NCC2022 SECTION J PART J4 PERFORMANCE-BASED DESIGN BRIEF (PBDB)

OPAL ST IVES BOTANICA

Project Number	250251
Project Name	Opal St Ives Botanica
Description	NCC2022 Section J Part J4 Performance-Based Design Brief (PBDB)
Key Contact	Onofrio Marzulli

DOCUMENT No.: 250251
 DOCUMENT TITLE: Opal St Ives Botanica - Building Fabric Requirement
 DOCUMENT REV: Rev A
 DOCUMENT BY: TST DATE: 14/11/2025

Drawing Title
 LOWER GROUND LEVEL

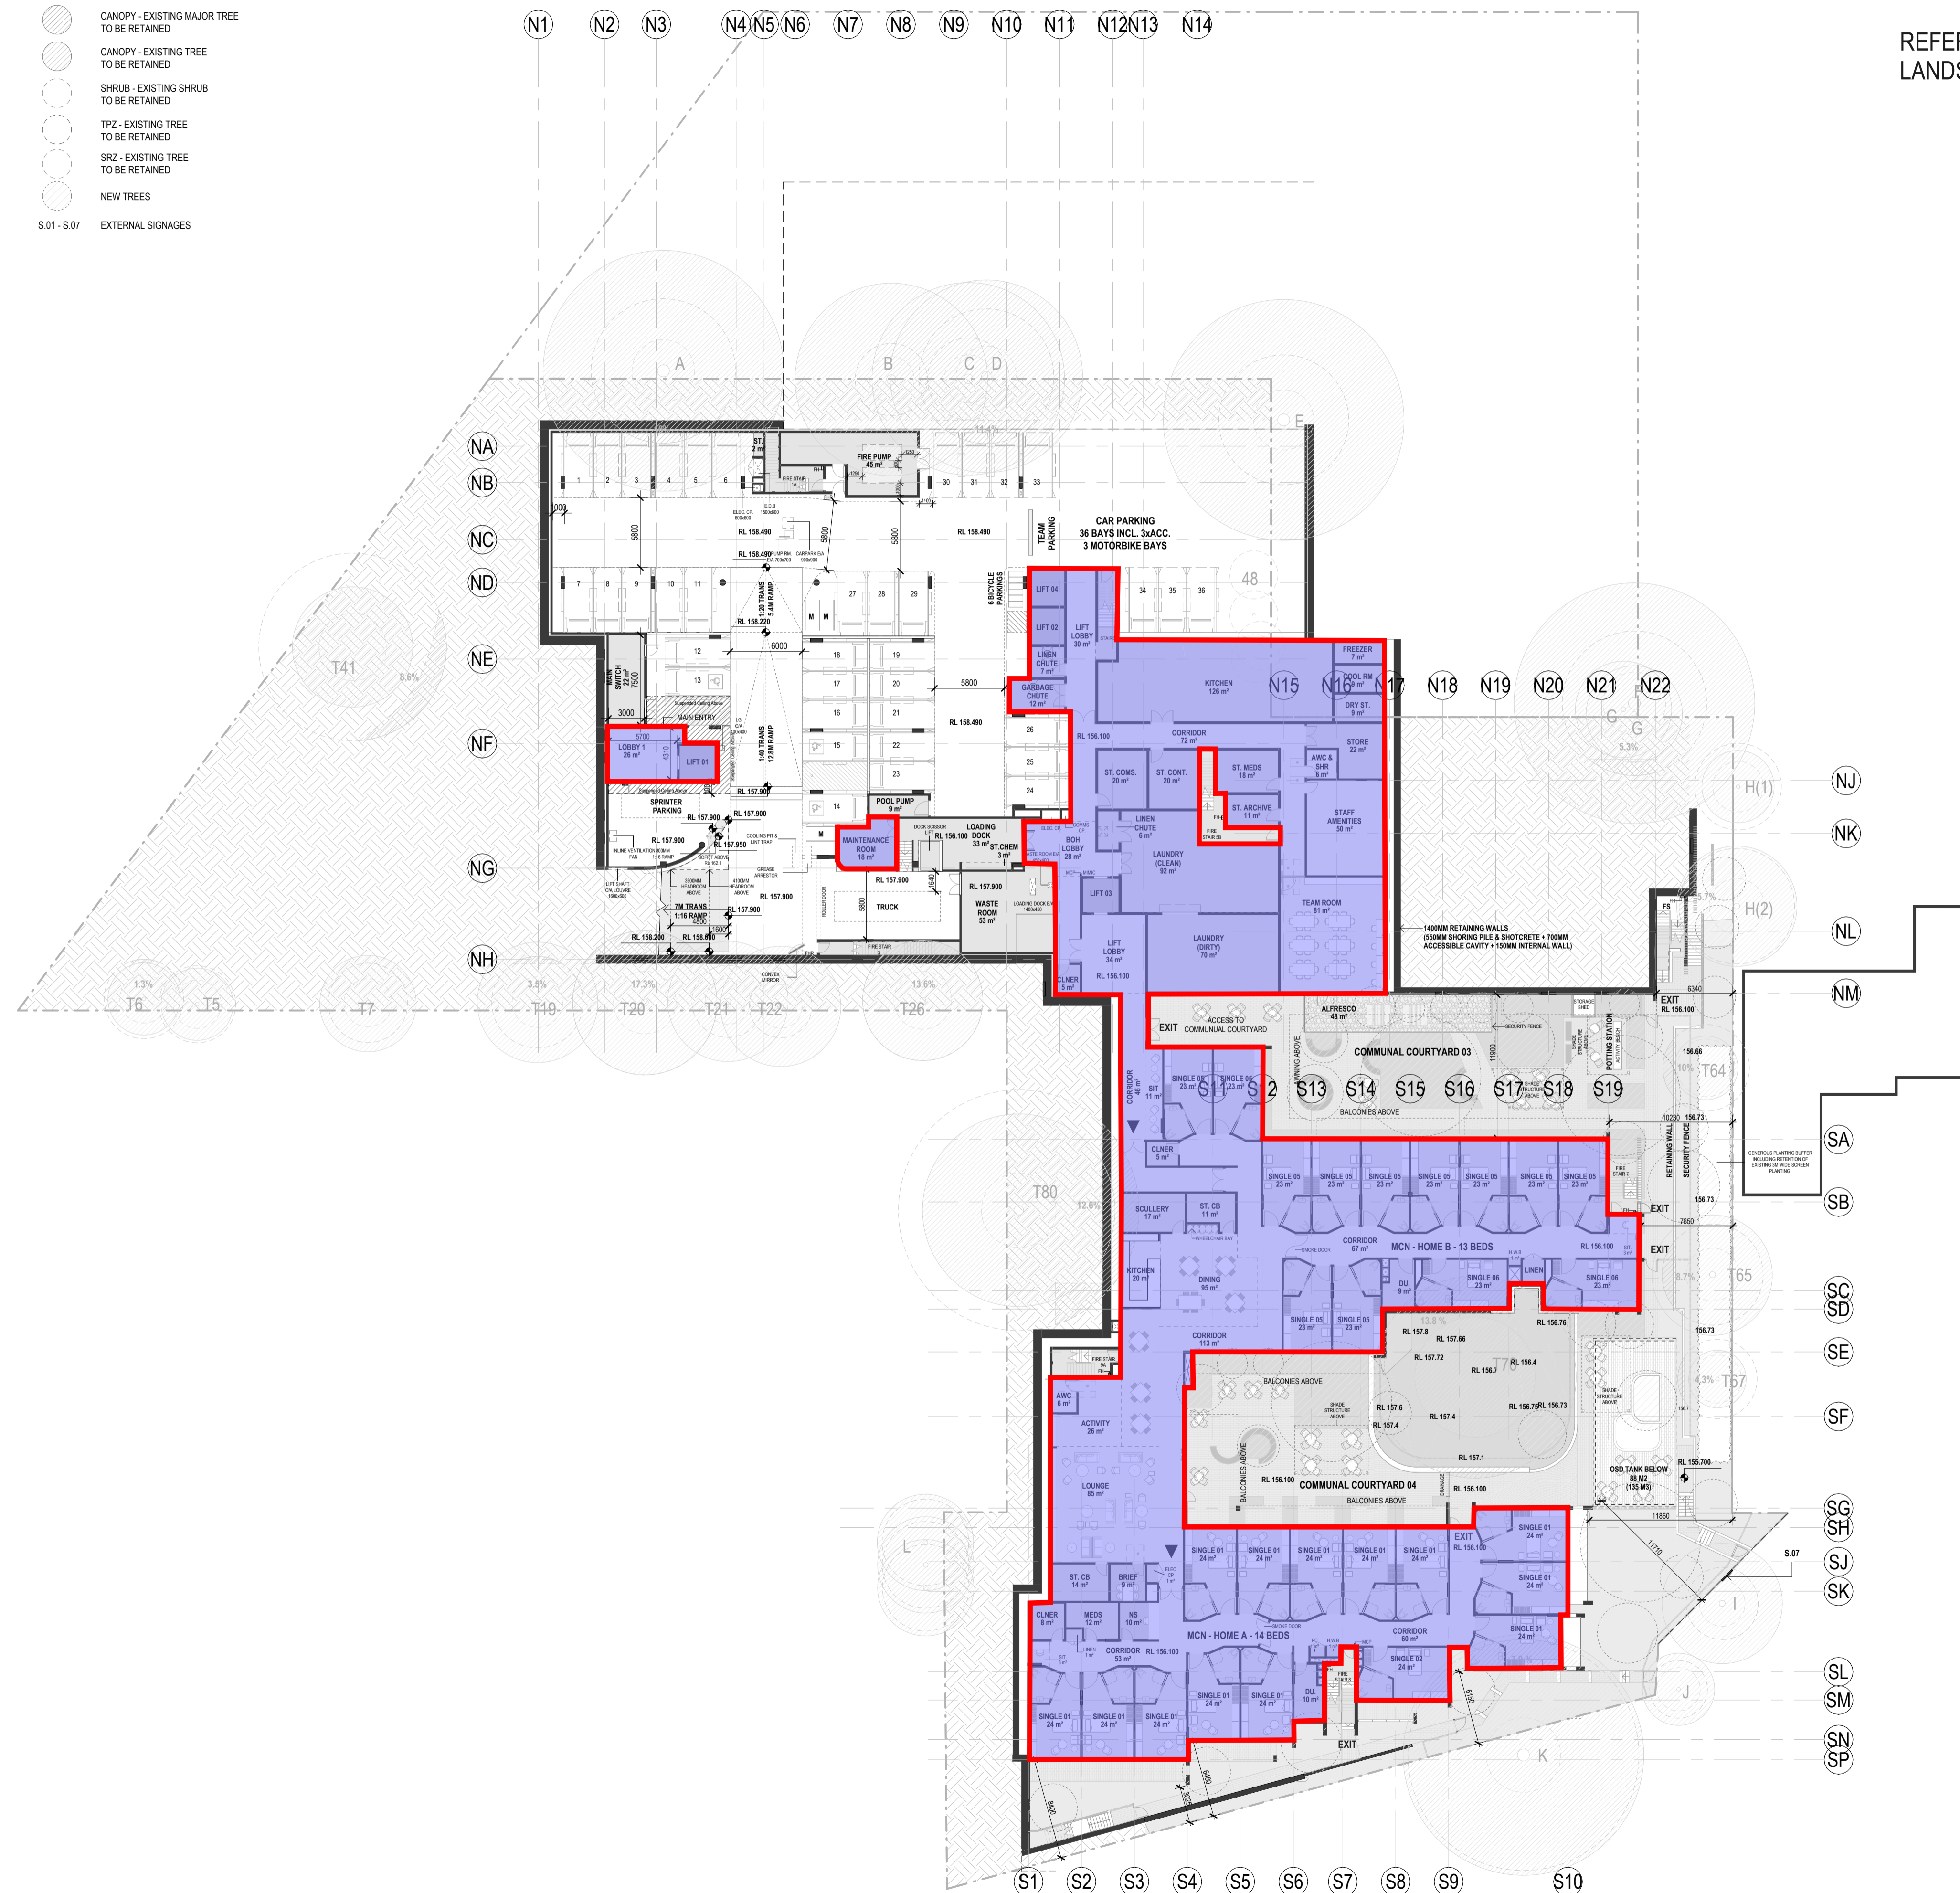
JHA
MARKUP / SKETCH

-  ROOF/CEILING ENVELOPE :- TOTAL R4.1 (DOWNWARD, SOLAR ABSOPTANCE NO MORE THAN 0.40)
-  ENVELOPE FLOORS (SUSPENDED):- TOTAL R2.2 (DOWNWARD)
-  ENVELOPE FLOORS (SLAB-ON-GROUND):- TOTAL R2.2 (DOWNWARD)*
-  ENVELOPE WALLS :- TOTAL R1.6

Note: The above construction are only to be applied to the non-glazed portions of the envelope; glazing must be installed as per the architectural layouts with its thermal performances pursuant to the respective glazing specifications stated in the Section J report (Total Systems U-Value, and Total Systems SHGC value).

* According to Clause 2 of Section J4D7, a slab-on-ground that does not have an in-slab heating or cooling system is considered to achieve a Total R-value of R2.0. Hence no additional insulation is required for Envelope Floors (slab-on-ground).

LEVEL 03

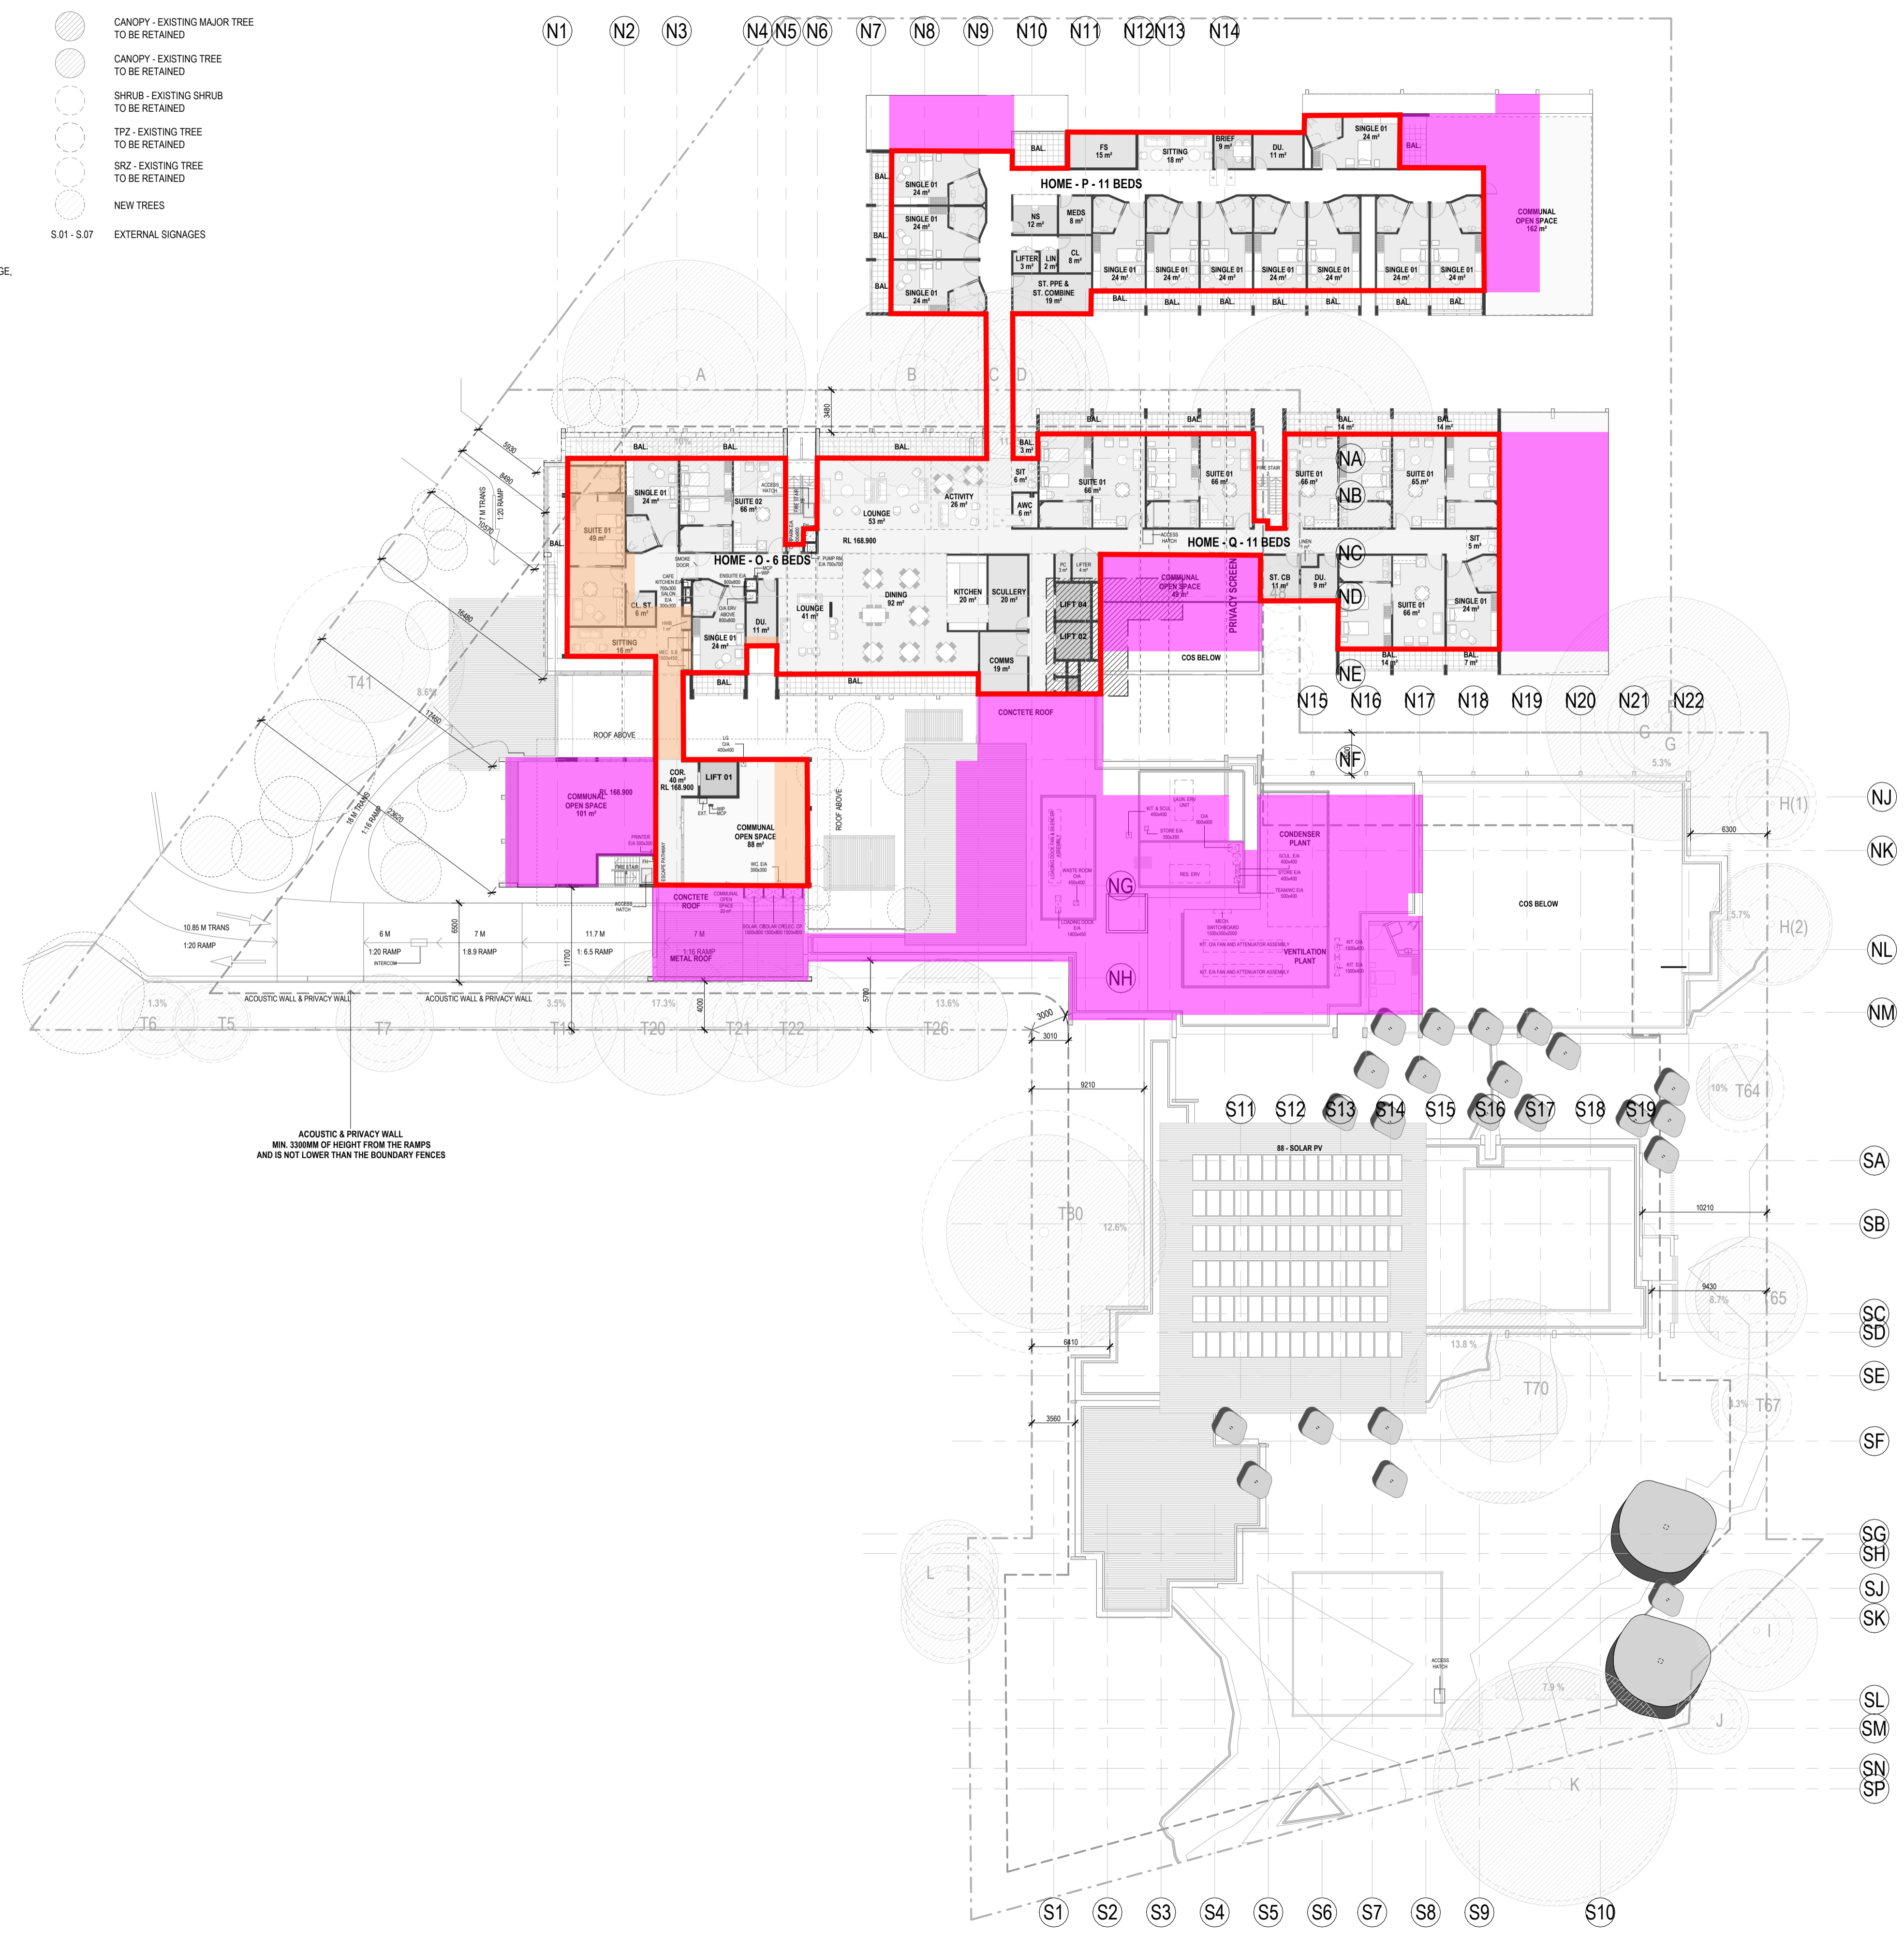
JHA
MARKUP / SKETCH

-  ROOF/CEILING ENVELOPE :- TOTAL R4.1 (DOWNWARD, SOLAR ABSORPTANCE NO MORE THAN 0.40)
-  ENVELOPE FLOORS (SUSPENDED):- TOTAL R2.2 (DOWNWARD)
-  ENVELOPE FLOORS (SLAB-ON-GROUND):- TOTAL R2.2 (DOWNWARD)*
-  ENVELOPE WALLS :- TOTAL R1.6

Note: The above construction are only to be applied to the non-glazed portions of the envelope; glazing must be installed as per the architectural layouts with its thermal performances pursuant to the respective glazing specifications stated in the Section J report (Total Systems U-Value, and Total Systems SHGC value).
